**TO:** Mills City Council  
**FROM:** Megan Nelms, AICP, City Planner  
**DATE:** February 25, 2025  
**SUBJECT:** Vision Beyond Borders – Development Plan

**Case Number:** 24.04 DEV

**Vision Beyond Borders  
Commercial Development Plan**

# SITE PLAN FOR VISION BEYOND BORDERS IN THE CITY OF MILLS NATRONA COUNTY, WYOMING

LIGHTING PLAN  
VISION BEYOND BORDERS  
MILLS, WY

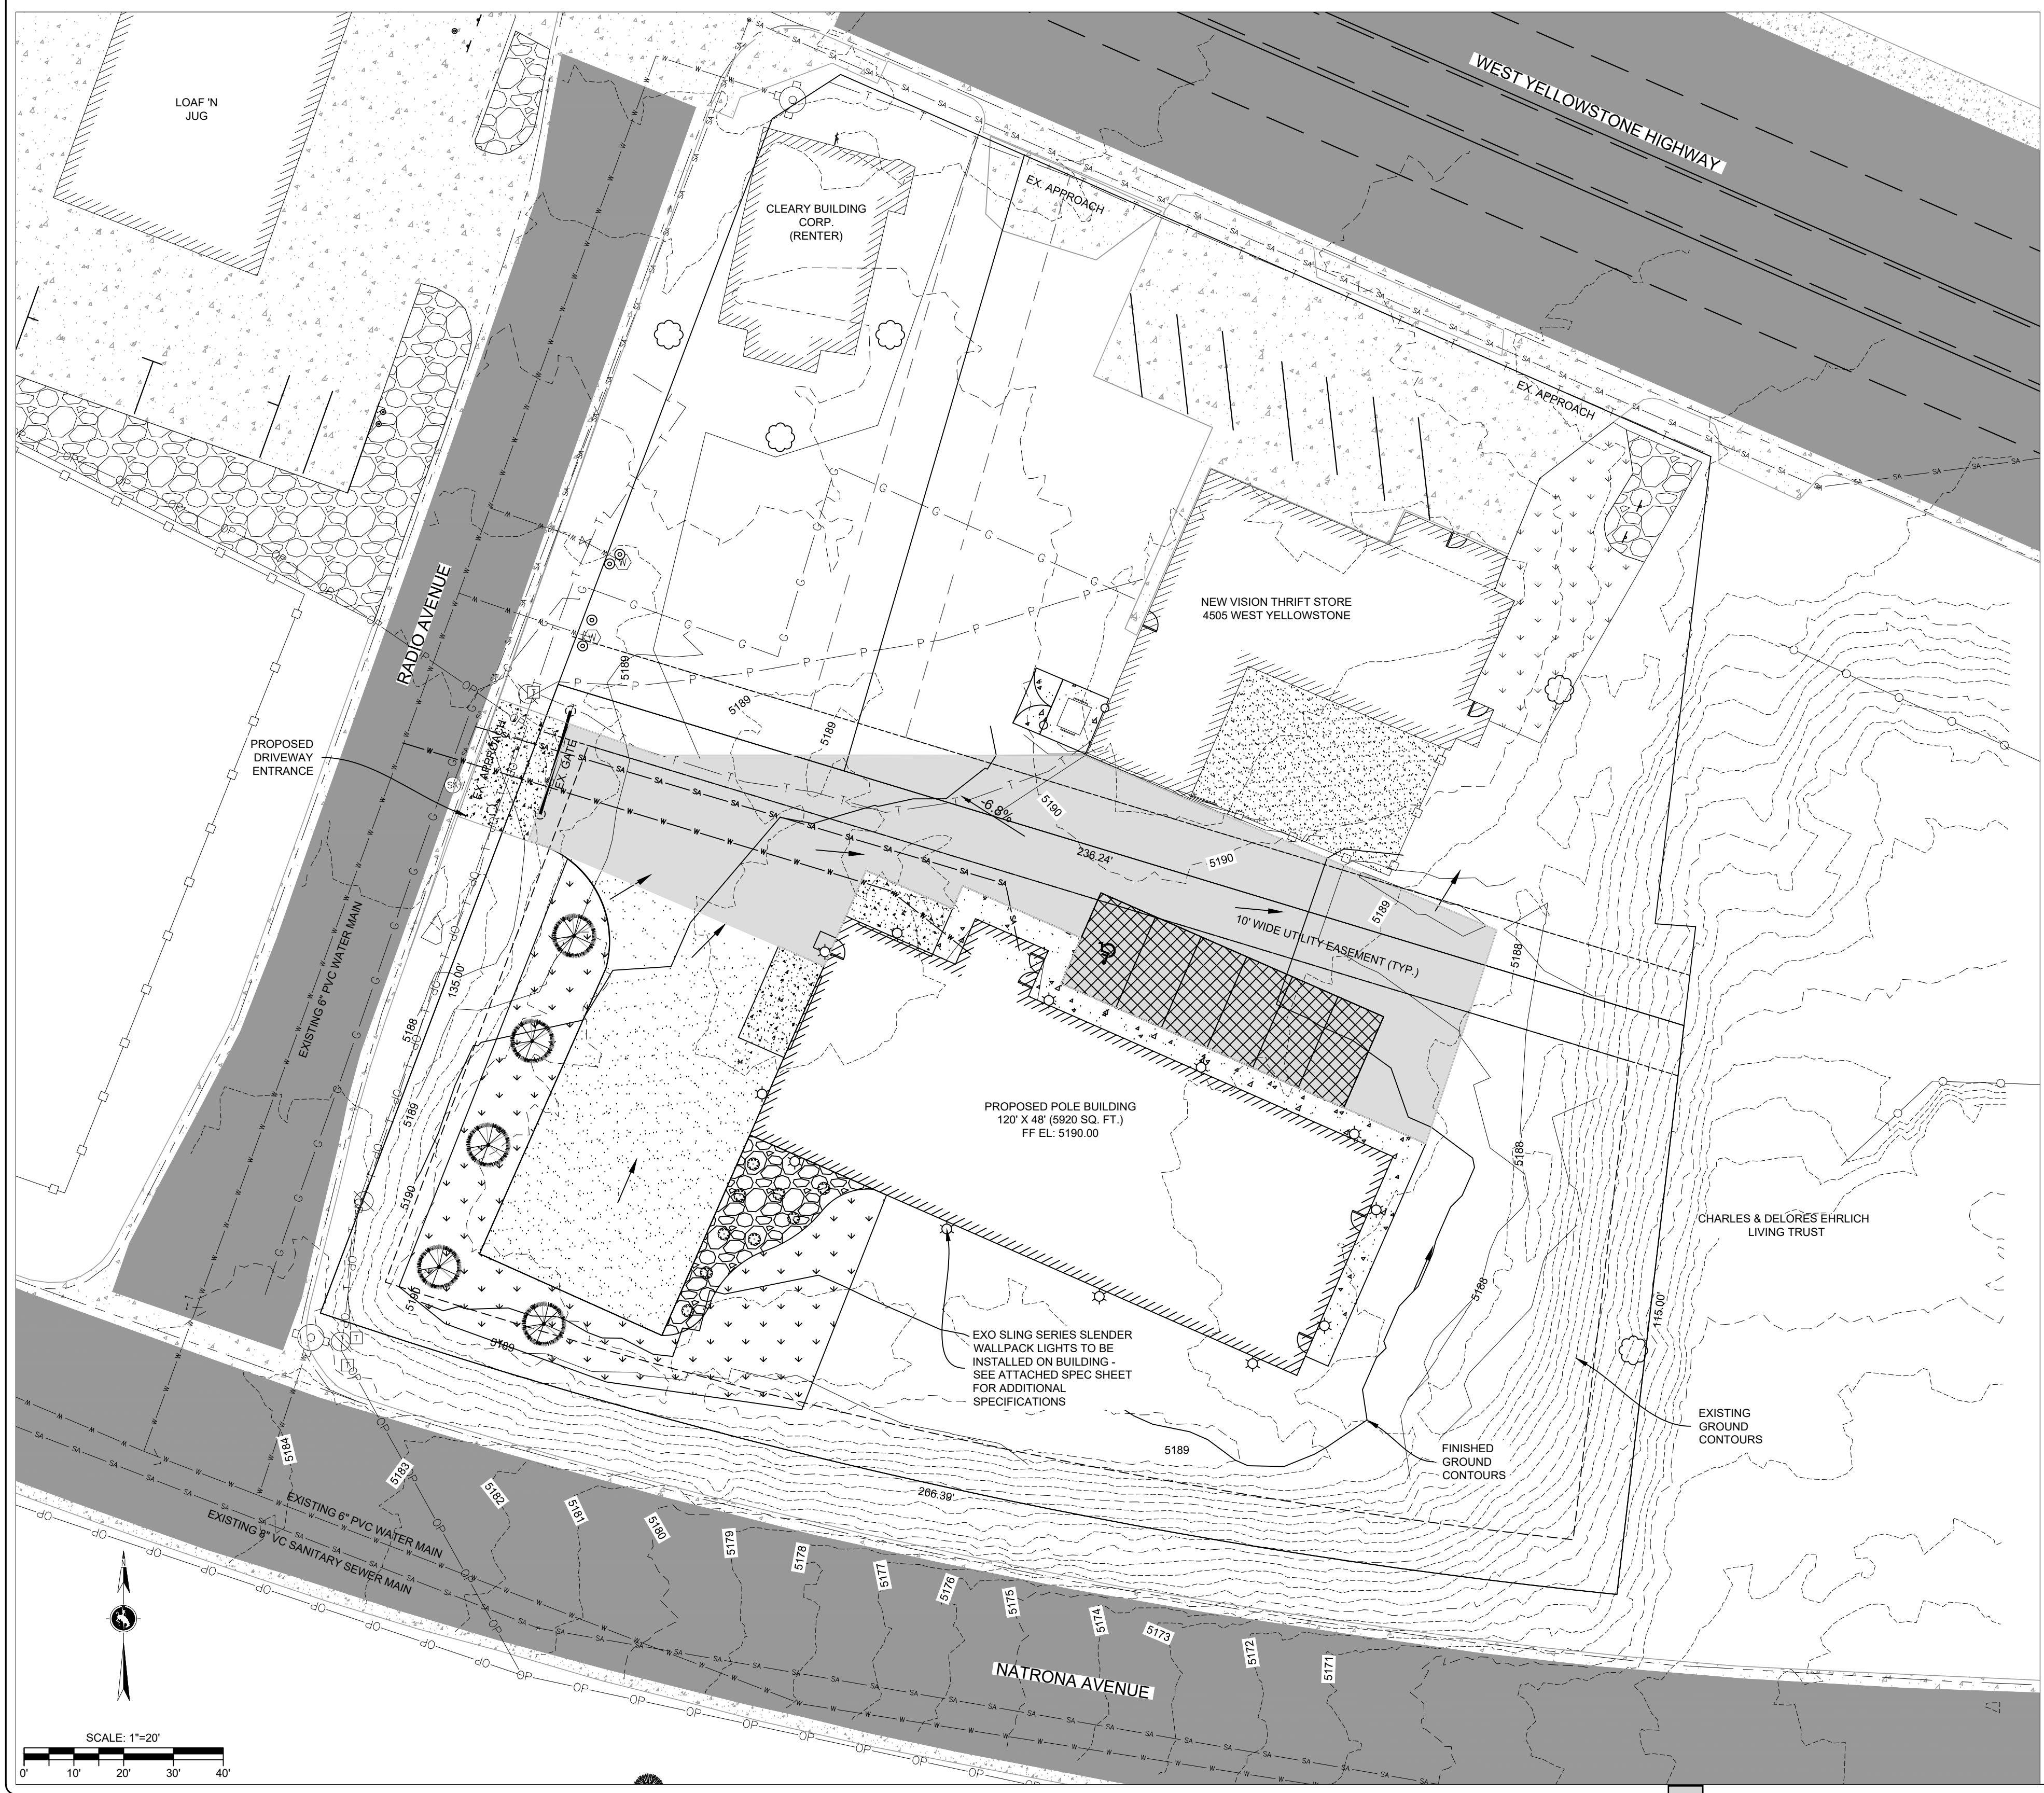
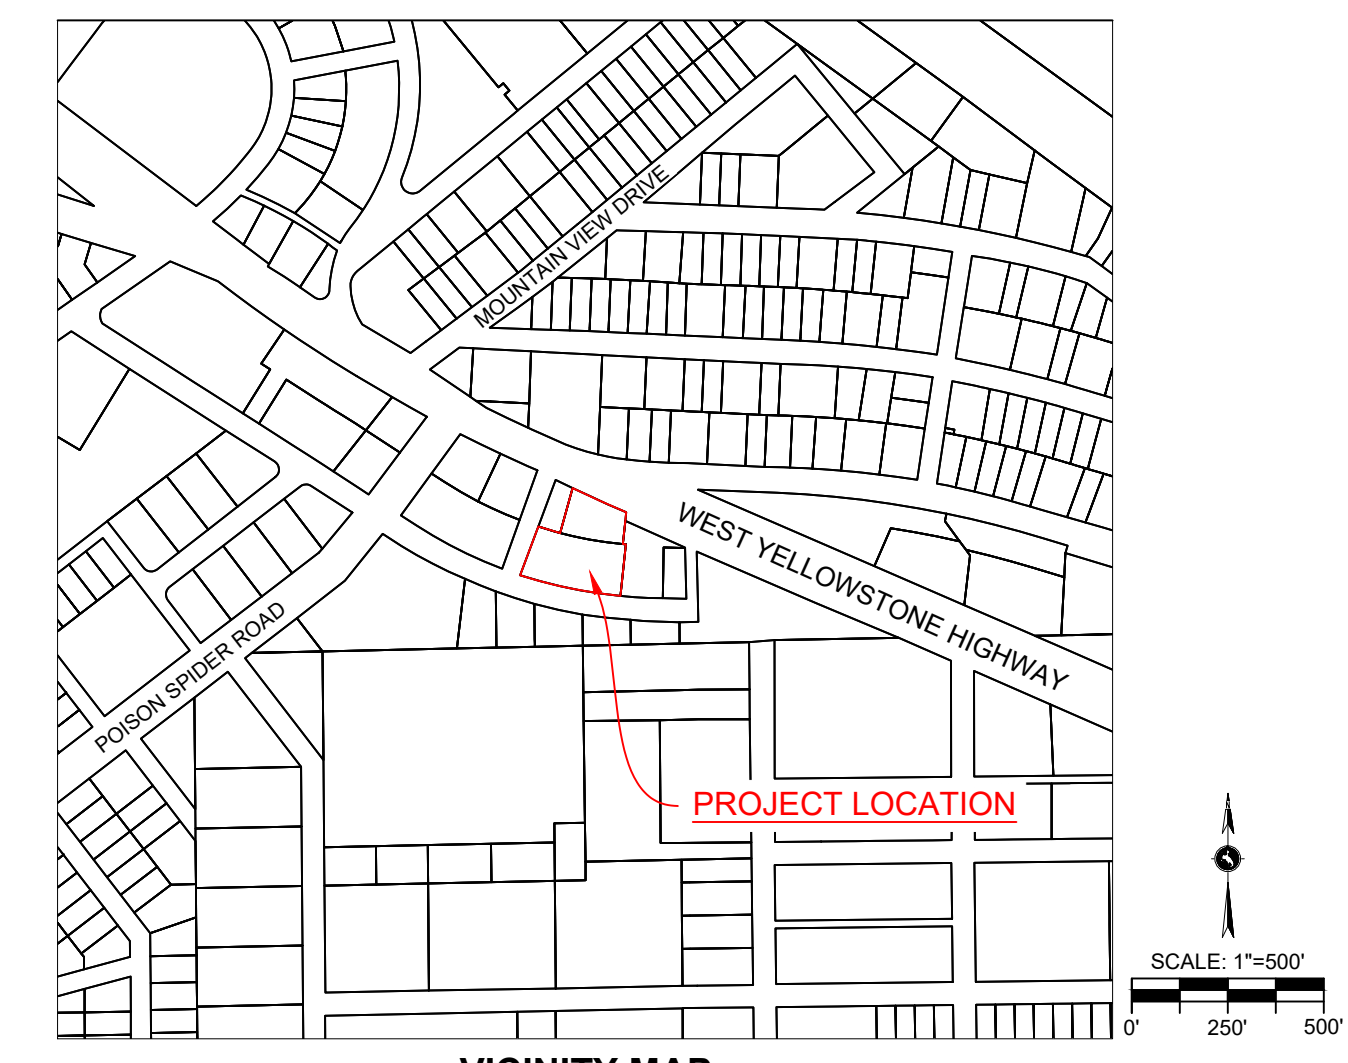
- a. No parking lot lighting is proposed
  - b. Exterior lighting will be limited to the building with shielded wall-packs. The applicant needs to specify which model of the Sling Series Slender Wallpack light will be utilized.
